31/7-98B 2801 Barker Street
(Capitol View Park Historic District)

**Expedited
Historic Preservation Commission Staff Report**

Address: 2801 Barker Street, Silver Spring **Meeting Date:** 04/22/98
Resource: Capitol View Park Historic District **Public Notice:** 04/08/98
Case Number: 31/7-98B **Report Date:** 04/15/98
Review: HAWP **Tax Credit:** None
Applicant: Emily & Harry Volz **Staff:** Perry Kephart

HOUSE LOCATION SURVEY

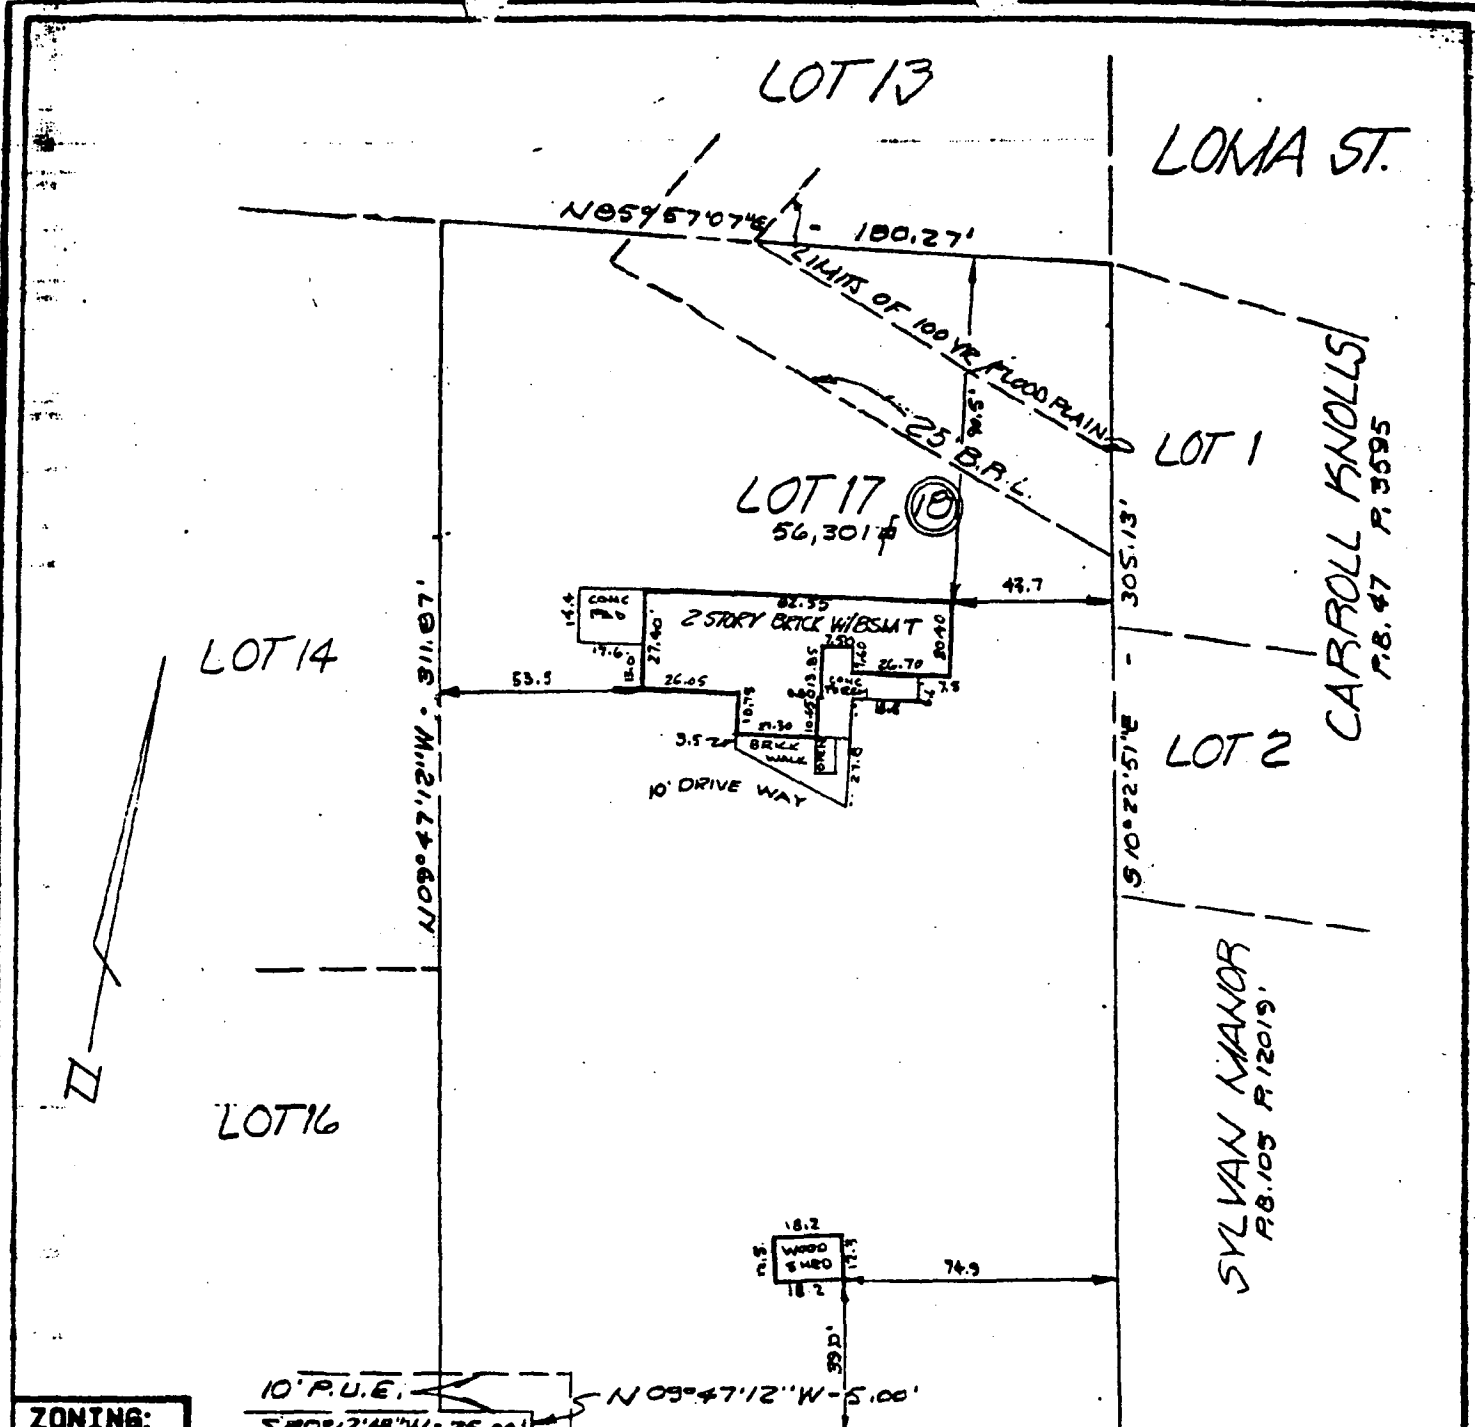
PROPOSAL: Remove six large trees over the next two years. They include a 14" hickory with root rot, a 10" box elder near the house, and a dying 16" dogwood to be removed this season. Next season removal is proposed for a 15" and 30" white oak, and a 24" oak.

RECOMMENDATION: Staff would concur with the need for normal forestry practices on this heavily wooded site. This would include the removal of diseased or dying trees. In staff's opinion, the three trees proposed for removal this season should be approved. The second set of trees could be monitored by the arborist as has been suggested in her accompanying letter. The HPC could also have the staff arborist visit the site with the homeowner and make a recommendation as to the future removal of the trees.

4. Trees 1, 2, 3 proposed for removal this season. Trees 4, 5, 6 proposed for future removal.

1. The oak trees be monitored and their removal be approved at staff level if that course of action is recommended by the staff arborist.
